ORIGINATION FORM

Proposed Revisions to a Standard Plans Index
(Please provide all information — Incomplete forms will be returned)

Index Number: 548-020
Sheet Number (s): Sheets 1 of 1
Index Title: MSE Retaining Wall Systems - Permanent

FDOT MSE RETAINING WALL CLASSIFICATION TABLE

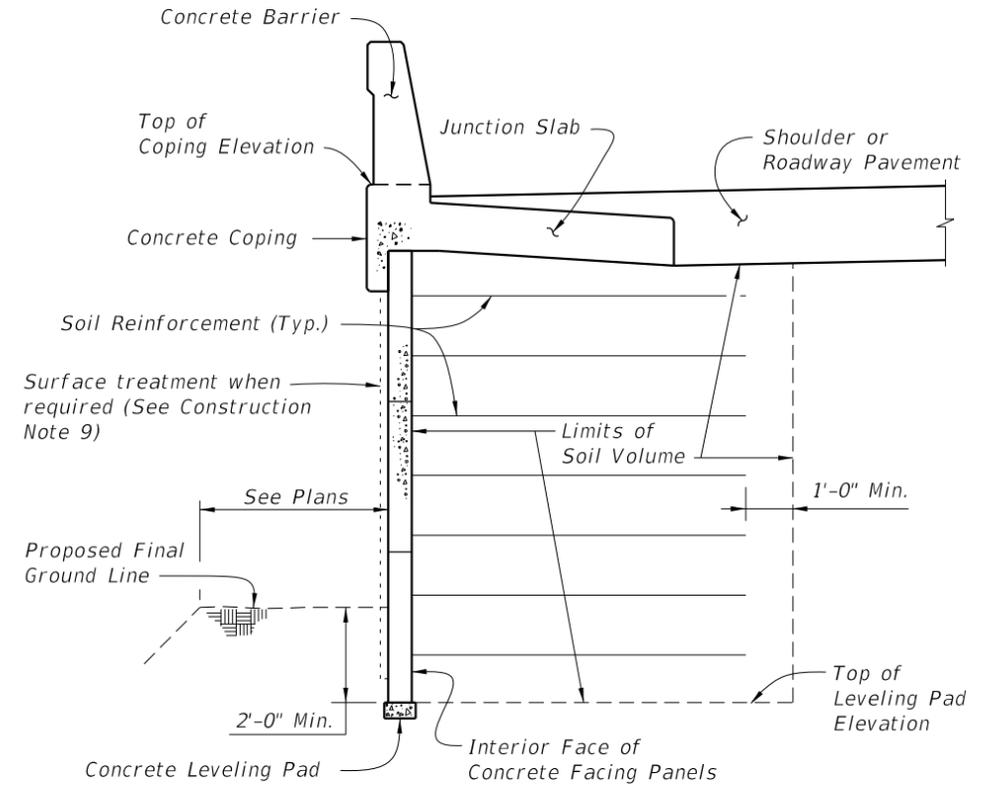
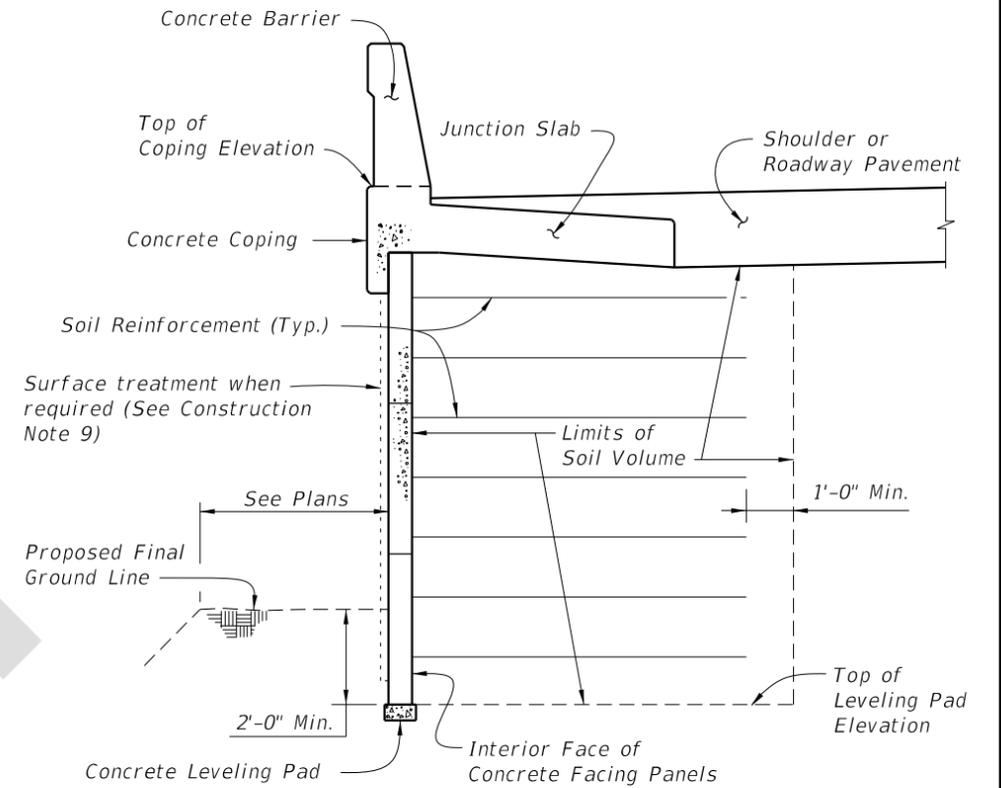
Removed alternative allowable wall type 2E from 2D.

Type 2E walls may not be able to accommodate the more aggressive environment condition that the type 2D is designated for per Dongming White.

Remove checkmark

Applicable FDOT Wall Type *	Durability Requirements (Carbon-Steel Reinforcing)			Durability Requirements (FRP Reinforcing)			Soil Reinforcement Type	Other Allowable FDOT Wall Types					
	Concrete Cover (in.)	Concrete Class for Panels	Pozzolan Additions? **	Concrete Cover (in.)	Concrete Class for Panels	Pozzolan Additions? **		2A	2B	2C	2D	2E	2F
Type 2A	2	II	No	1.5	II	No	Metal		✓	✓	✓	✓	✓
Type 2B	2	IV	No	1.5	IV	No	Metal			✓	✓	✓	✓
Type 2C	3	IV	No	1.5	IV	No	Metal				✓	✓	✓
Type 2D	3	IV	Yes	2	IV	No	Metal						✓
Type 2E	3	IV	No	2	IV	No	Plastic						✓
Type 2F	3	IV	Yes	2	IV	No	Plastic
